Water Pump Base Cracked – 50 thru 60

Mariner/Mercury 1997 50/55/60 HP

USA 0G554271 thru 0G567001

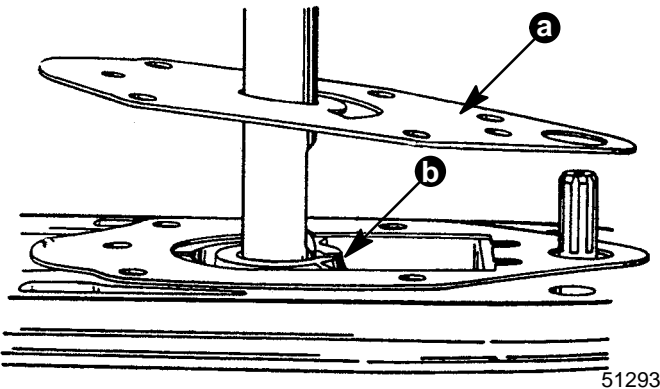
The water pump base on the models listed may crack and allow water to enter the gearcase causing a premature gear failure. Product previous to the serial numbers listed are not affected. The crack is caused by a combination of brittle material and incorrect clearance for the seal. A new water pump base p/n 46-812966A9 is changed in design and made of a more durable material to resist cracking.

a - Water Pump Base Plate

b - Front Area May Crack

50554

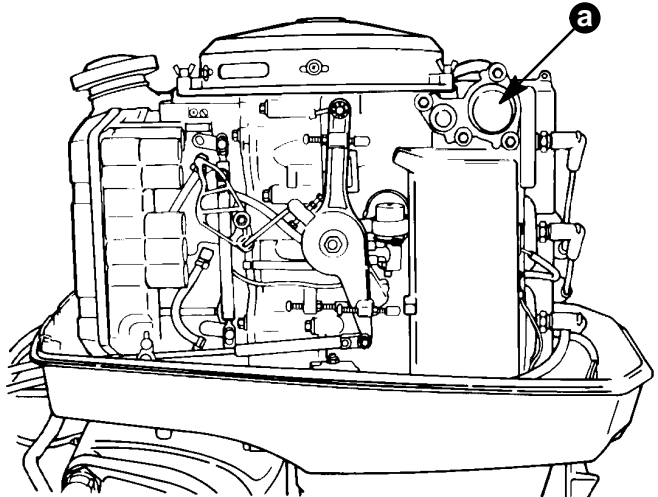
Install a new water pump base p/n 46-812966A9, install new water pump gaskets, pressure test, assemble lower unit to outboard, and identify that the outboard was repaired by placing a white paint dot on the thermostat/poppet valve cover.

Repair at the dealership should be marked with a white dot on the thermostat/poppet valve cover.

a - Thermostat/Poppet Valve Cover

51206

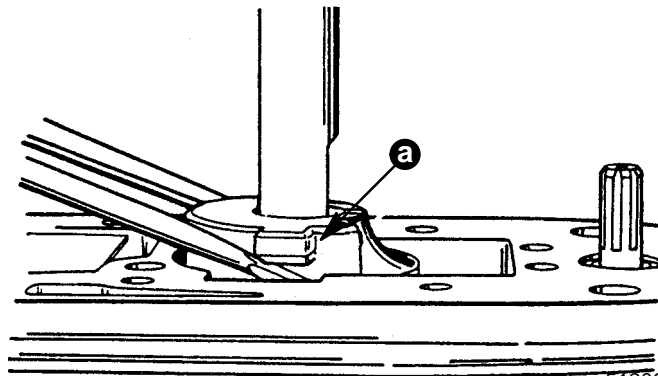
The previous water pump base p/n 46-812966A3 has a pry tab on each side to assist in removal from the gear housing.

a - Pry Tabs

55874

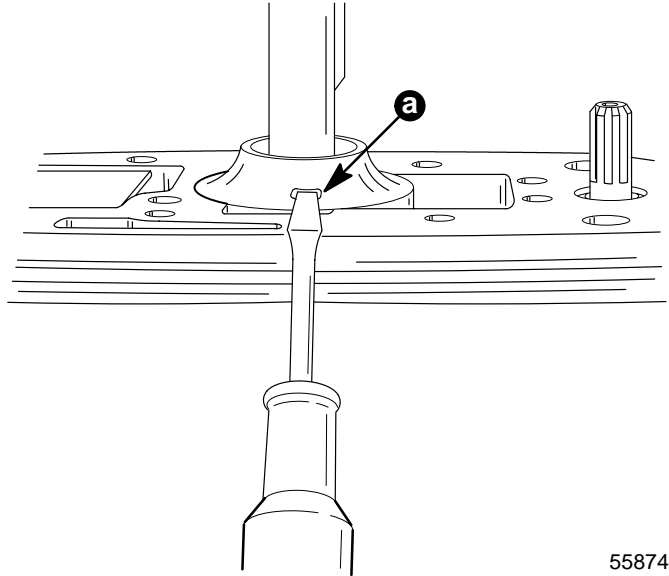
New water pump base p/n 46-812966A9 has a pry slot on each side to assist in removal from the gear housing. The slots must be positioned to the sides of the gear housing to allow for easy removal of the base if future servicing is required.

a - Pry Slots.

55878

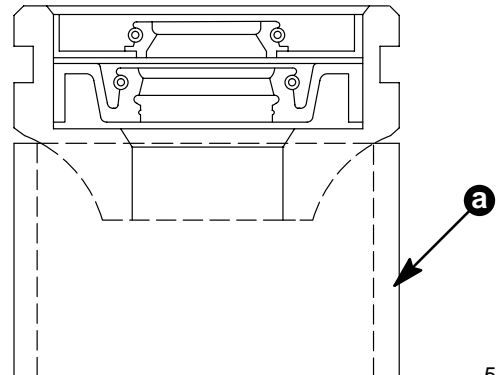
The water pump base must be properly supported on the outer edge when installing the seals into an empty base. The base is thinner on the outer edge of the seal area and breakage could occur if it is supported only on the center. Use a suitable mandrel that supports and contacts the outer surface of the base.

a - Support Mandrel.
